Vermeer MV Solutions, Inc.

FIELD CAMPAIGN KIT #: VMV000108
For Dealer Reference: Service Bulletin #: SMV2026-001

Boom Raise Cylinder Pins and Retaining Clips Update Kit

CAMPAIGN TYPE:	Mandatory – Product Compliance DEALER INSTALLATION ONLY
CAMPAIGN CATEGORY:	Kit and Bulletin

Figure A

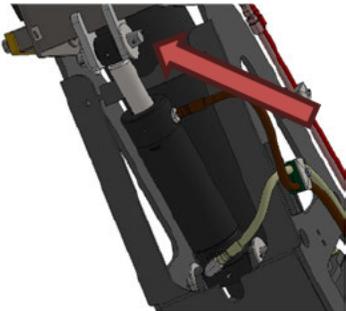
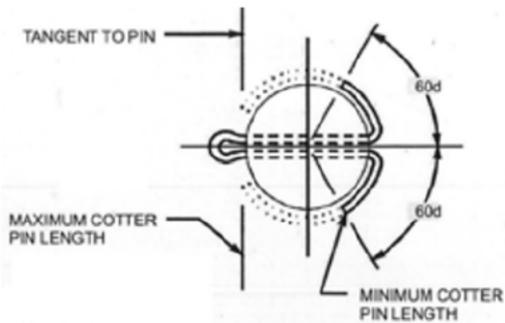
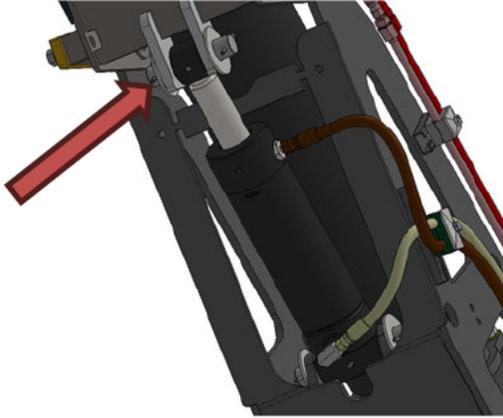
Purpose: *BOOM CAN FALL UNEXPECTEDLY. During manufacturing, the incorrect boom raise cylinder retainer clips may have been installed. The retaining clips can become displaced during operation and the boom may fall. Death or serious injury is possible if the boom falls and strikes or crushes an operator or crew member. Machine or property damage is also possible.*

2. Position ladder so that you will maintain steady balance and keep three points of contact. Do not to remove pin during these proceeding steps.
3. Remove existing clips from the base boom rod side pin.
4. Install washers and cotter pins according to Figure A at the boom raise/lower cylinder rod side pin location shown below.

5. Grease the rod pin point before operation.

Figure 1

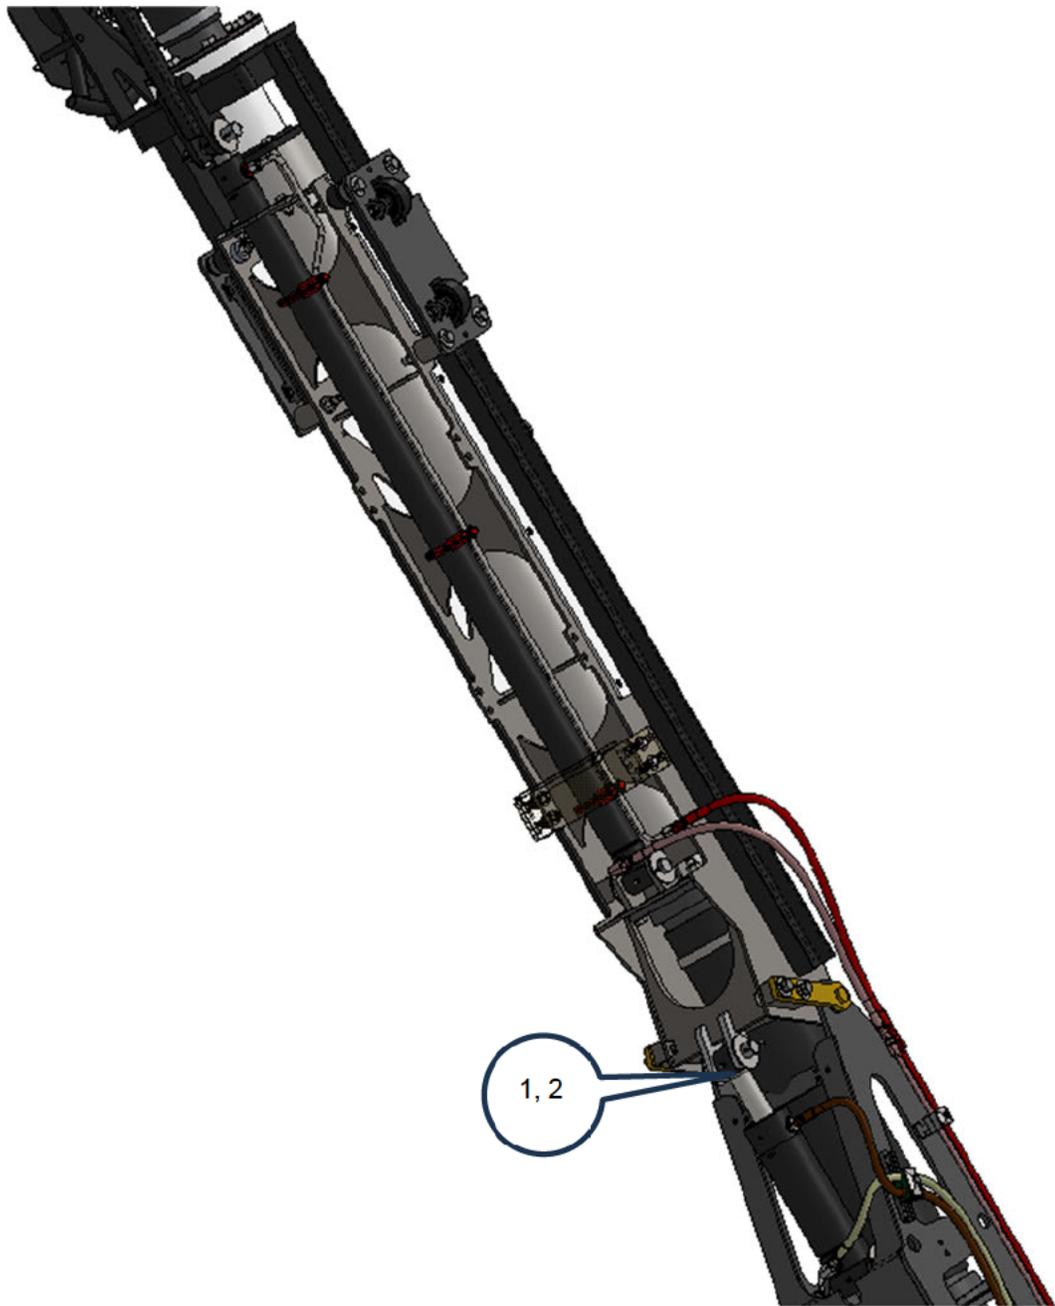
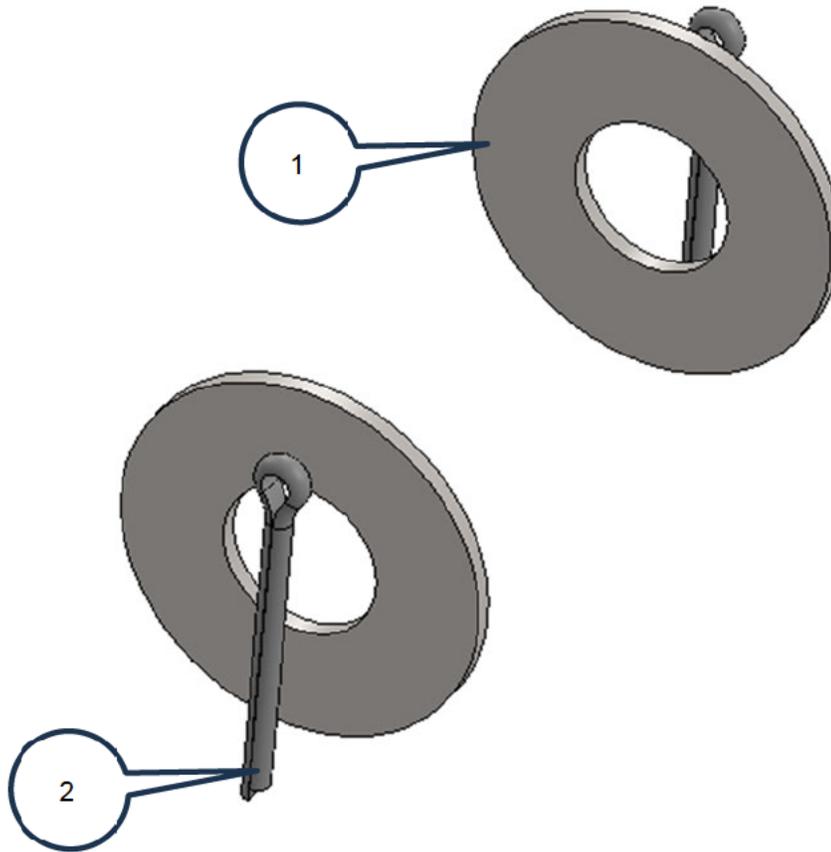
6. Remove Figure 1 \ 1.1 and place in the manual storage box so unit owner can place with existing parts manual.

<u>REF. NO.</u>	<u>PART NO.</u>	<u>DESCRIPTION</u>	<u>VMV01 QTY.</u>
1	U200170	WASHER FLAT 1.000	2
2	U320070	PIN,COTTER .188X2.000	2
		Kit includes all items in Figure 1 parts list.
